**Re: West Elbow Communities Local Area Plan (WEC-LAP) Bylaw
Public Hearing – Tuesday May 6, 2025**

Re: **Feedback on West Elbow Communities Local Area Plan Draft Chapter 2**

**Collective Proposed Amendments
to the
West Elbow Local Area Plan
May 1, 2025**

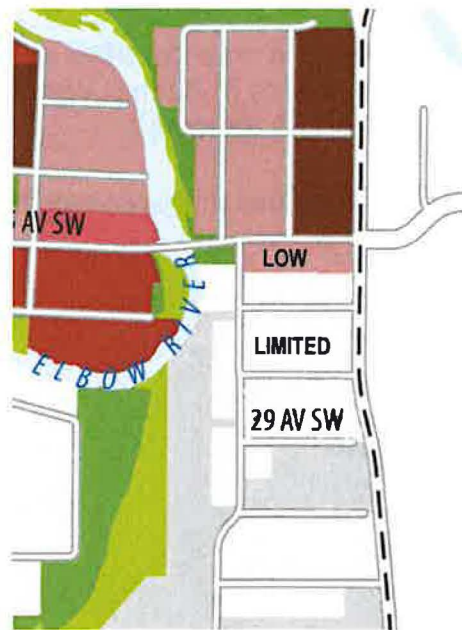
1. Amend Map 4 entitled 'Building Scale' to change the area identified as 'Low Modified (up to 4 Storeys)' on Elbow Drive SW between 38th Ave SW and Sifton Boulevard SW, to 'Parks and Open Space'; and to change the area identified as 'Low Modified (up to 4 Storeys)' one block west of Elbow Drive SW on both 38th Ave SW and on Sifton Boulevard SW, to 'Limited (up to 3 Storeys)

2. Amend Map 4 entitled 'Building Scale' to change the area identified as 'Low Modified (up to 4 Storeys)' on the west side of Elbow Drive SW from just north of Garden Crescent SW to 38th Ave SW and on the east side of Elbow Drive SW from just south of 34th Ave SW to 40th Ave SW, to 'Limited (up to 3 Storeys)
3. Amend Map 4 entitled 'Building Scale' to change the area identified as 'Low Modified (up to 4 Storeys)' on the both the north and south side of Council Way SW from 14th Street SW to 12th Street SW, to 'Limited (up to 3 Storeys)
4. Amend 2.2.1.4 Neighbourhood Local to add provisions that acknowledge community context as it pertains to:
 - building massing
 - lot coverage
 - site setbacks
 - access to sunlight
 - the protection of healthy, mature trees

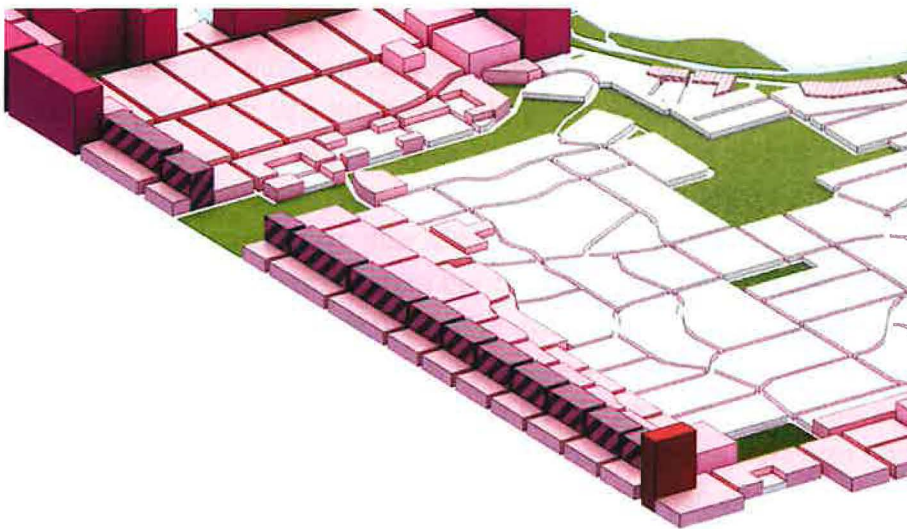
5. Amend the 50th Avenue corridor to allow a maximum of 4- storeys without commercial development.

Rationale: Although 50th Avenue is designated as a Community Corridor in WELAP, the stretch between 22nd Street and 20th Street SW is already severely congested, often backing up onto northbound Crowchild trail on the east bound side or backing up beyond the 4 -way stop at 20th Street on the westbound side. This is due in part to the proximity of a high school with approximately 1,500 students, and other nearby schools. The planned expansion of Glenmore Athletic Park will further exasperate this congestion. With 33rd and 34th Avenues being redesigned for pedestrian use, 50th Avenue has increasingly become a critical east-west access route for residents. Given the geographic constraints— Glenmore Trail on one side and the Reservoir on the other— our community has few exit points. Adding more density and potential commercial development

along 50th Avenue will worsen congestion and make it even more difficult for residents to enter and exit the community safely and efficiently.

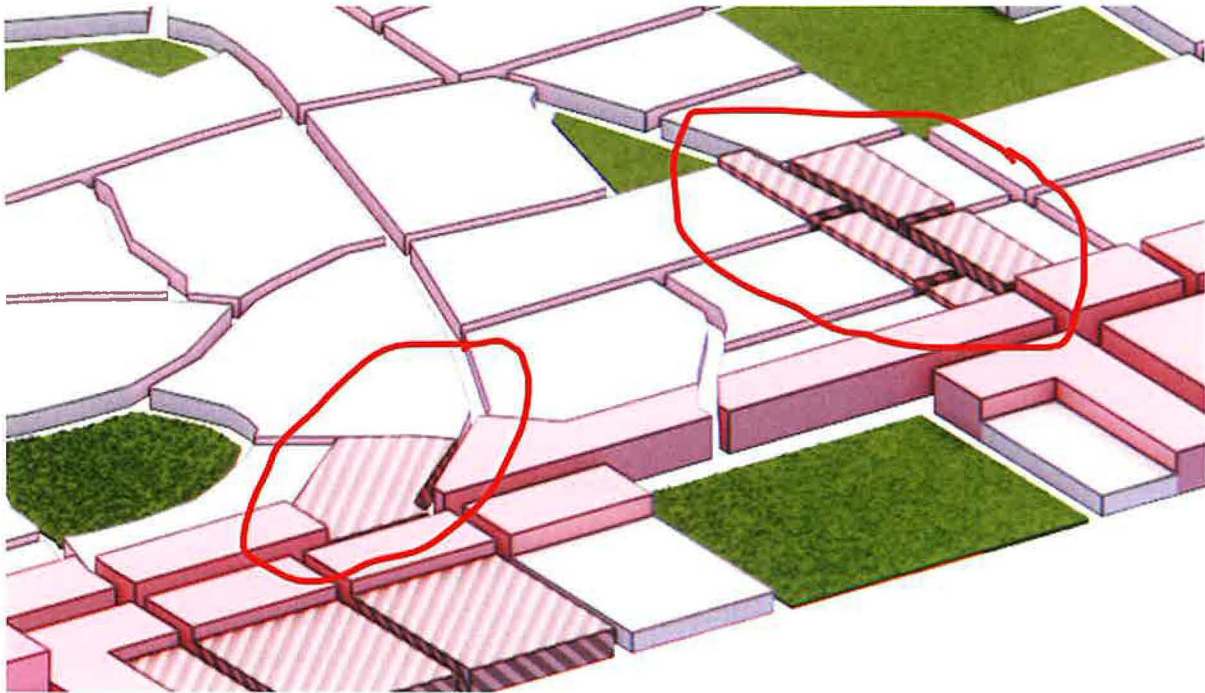
1. Lower Mount Royal is suggested to have 12-26 stories which will effectively destroy the area as land values will skyrocket, speculators will come in and run buildings down to milk the last revenue out of them. This is a new form of urban renewal/slum clearance from the 1950's but this time it is the private market that is creating havoc and encouraged by the City. This will result in loss of significant affordable housing presently in place, as LMR the second cheapest rental district in the City.

2. Height limits on 17th Ave have been kept down over the years to maintain sunlight reaching the north side and to make the street comfortable in a pedestrian scale environment. It is worth reviewing how to ensure 17th Ave remains a vibrant pedestrian street.

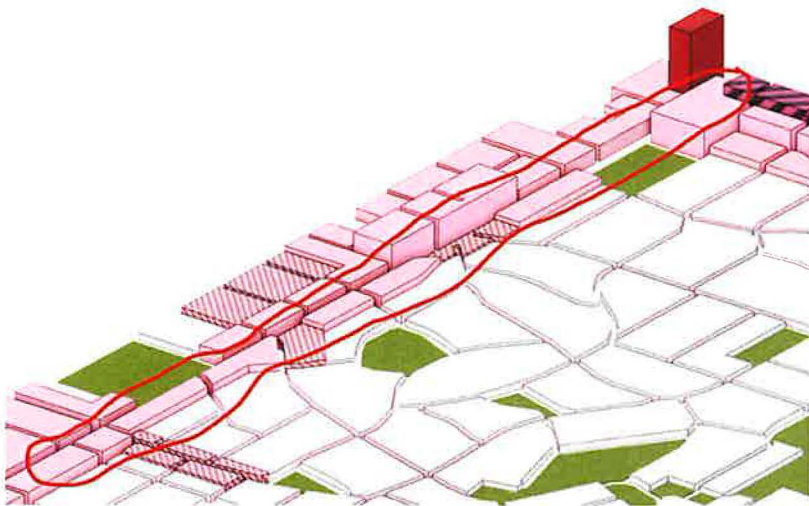
3. Protrusions into the heart of Mount Royal on Prospect and Council Way. There is no reason to do so and those properties should have the same low density form as properties beside it.

EXISTING PLAN OF A PROPOSED UPZONED AREA ON 17TH AVE SW

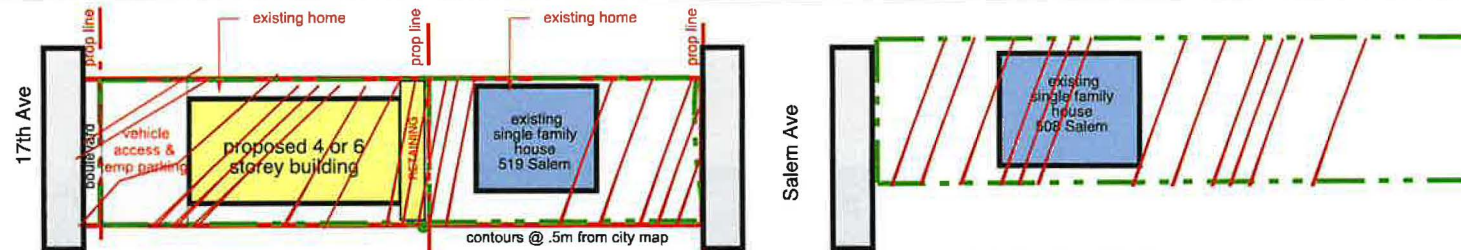
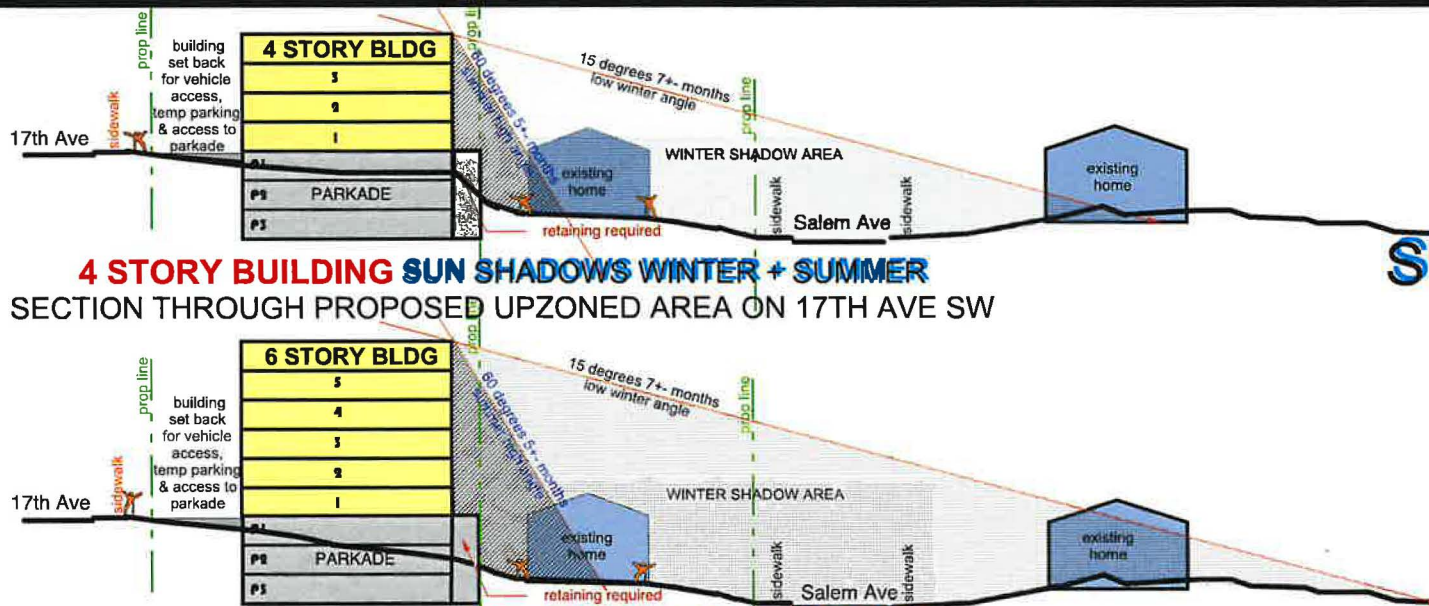
We are very fortunate to have in our community a well-respected Calgary architect, Harvey Bernbaum. At my request, Mr. Bernbaum has prepared drawings that illustrate the shadowing effect of constructing 4 and 6 storey buildings all along the 17th Avenue boundary of Scarboro. I expect that Mr. Bernbaum will be presenting these drawings to you at the Council meeting scheduled for May 6, 2025. Once you have had an opportunity to see these drawings, I believe that you will quickly come to understand the potentially devastating impact that this proposed 17th Avenue development would have on the sunlight reaching the community. I would simply add that it was necessary to seek Mr. Bernbaum's assistance when the West Elbow LAP planning team refused to share the City's own study dealing with the same matter.

4 STORY BUILDING SUN SHADOWS WINTER + SUMMER
